MONTGOMERY COUNTY HISTORIC PRESERVATION COMMISSION
STAFF REPORT

Address:	101 Primrose St., Chevy Chase	Meeting Date:	6/28/17
Resource:	Contributing Resource Chevy Chase Village Historic District	Report Date:	6/21/17
Applicant:	Lisa & Richard White	Public Notice:	6/14/17
Review:	HAWP	Tax Credit:	N/A
Case Number:	35/13-17M	Staff:	Dan Bruechert
Proposal:	Side and rear addition and window alteration

PROPOSED NORTH ELEVATION

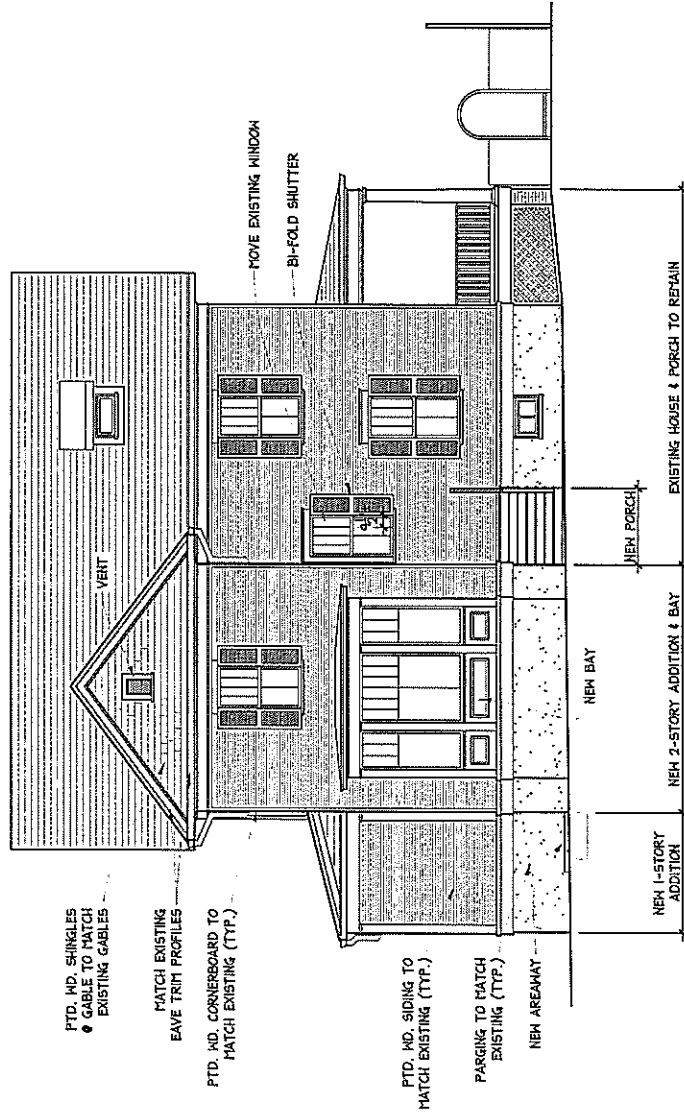
The north elevation of the addition has a rectangular bay on the first floor and a four-over-two lite window above. The bay has a gently sloping hipped roof with fixed three-over-one lite windows flanking a central, fixed six-over-two lite window. Below the windows will be wood panels that match the details on the one-story addition. The roof gable will have a small rectangular vent and is proposed to be clad in wood shingles that match the appearance of the historic house.

In order to accommodate the new addition, a historic four-over-two lite window on the north elevation will be moved to the right several inches. The historic material and appearance of this window will be preserved and this proposed work will not have an adverse effect on the historic character of the house or the surrounding district (Chapter 24A-8(b)(2)).

PROPOSED EAST ELEVATION

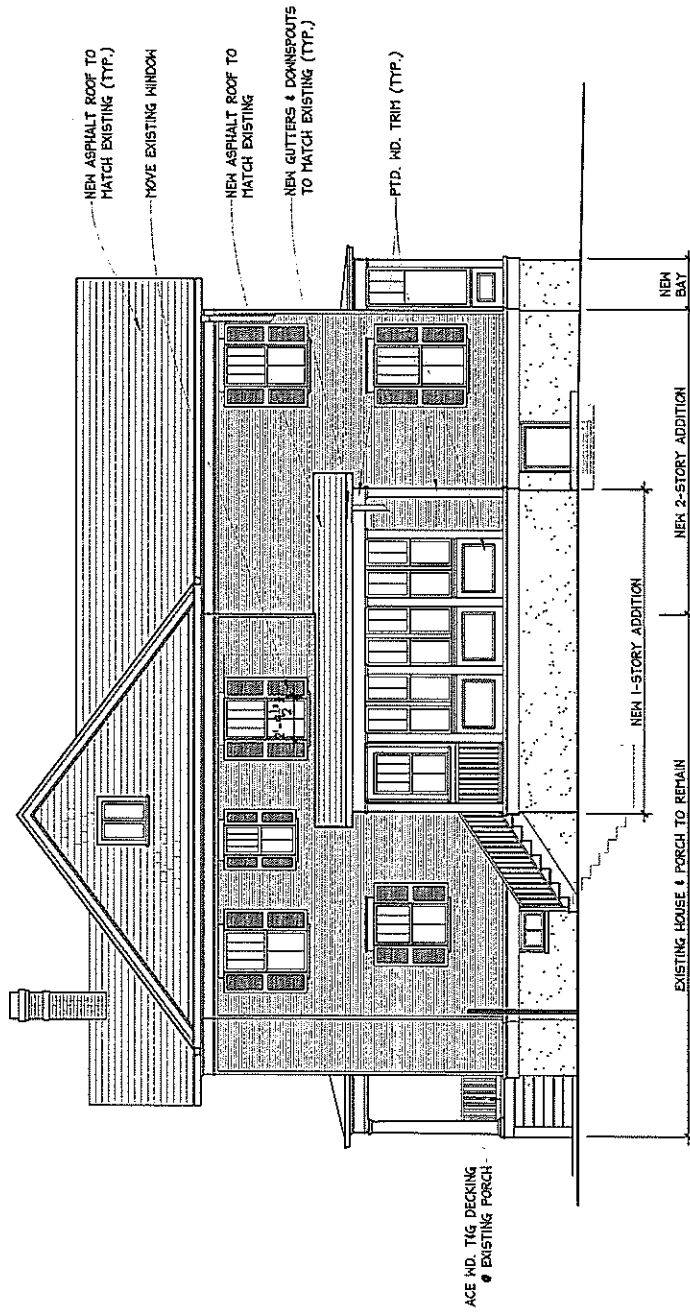
The proposed one-story addition will be placed along the east elevation at the right side of the Primrose St. elevation. From the street, the proposed addition will read as a wood-clad, shed-roof addition. The half-lite entrance door with a transom above will be accessed up 8 (eight) steps. Exterior wall cladding, trim, roofing, and gutters on the proposed addition will all match the historic materials on the historic core of the house. Additionally, the proposed addition will provide direct basement access via a new set of exterior stairs and a door to be installed below grade.

The east side of the addition includes three sets of paired two-over-one lite windows with a wood panel below. These windows are sufficiently differentiated from the historic four-over-two light windows so as not to be mistaken for historic, but are compatible with the whole of the house. Due to the siting of the house on the lot, the east elevation will not be visible from the public right-of-way. This proposal is compatible with the historic character of the house (Chapter 24A-

PROPOSED WEST ELEVATION

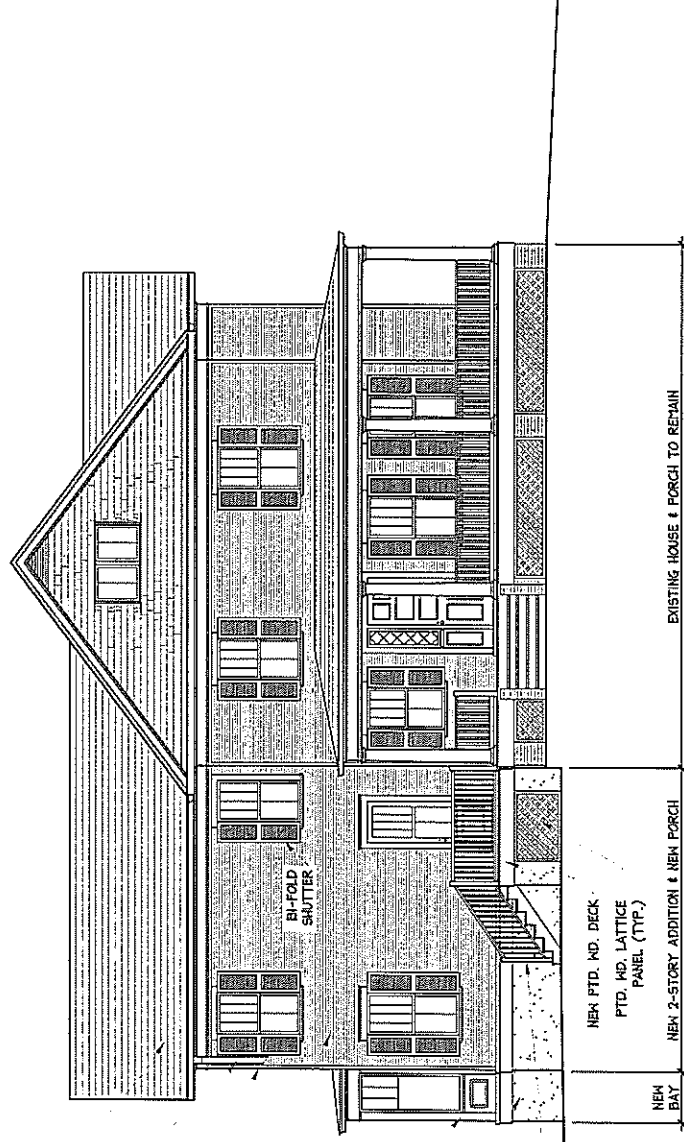
The proposed two-story addition will be placed to the left of the Brookville Rd. (west elevation). This proposed addition will be two-stories tall, with an asphalt-shingled side-facing gable roof. The with wood clapboard siding, trim, shutters, gutters and downspouts, and four-over-two windows will all match the architectural details on the historic house. The wall plane of the addition is setback 16' 8 ½" (sixteen feet, eight and one-half inches) from the front wall plane of the historic house.

The west elevation of the proposed addition includes a single four-over-two lite window and a half-lite door that will be accessed by a new, simply detailed wood porch constructed on parged piers. The second floor of the addition has two four-over-two lite windows matching the appearance of the historic house. The right window only has a single bi-fold shutter due to the window's placement close to the north wall of the historic house.
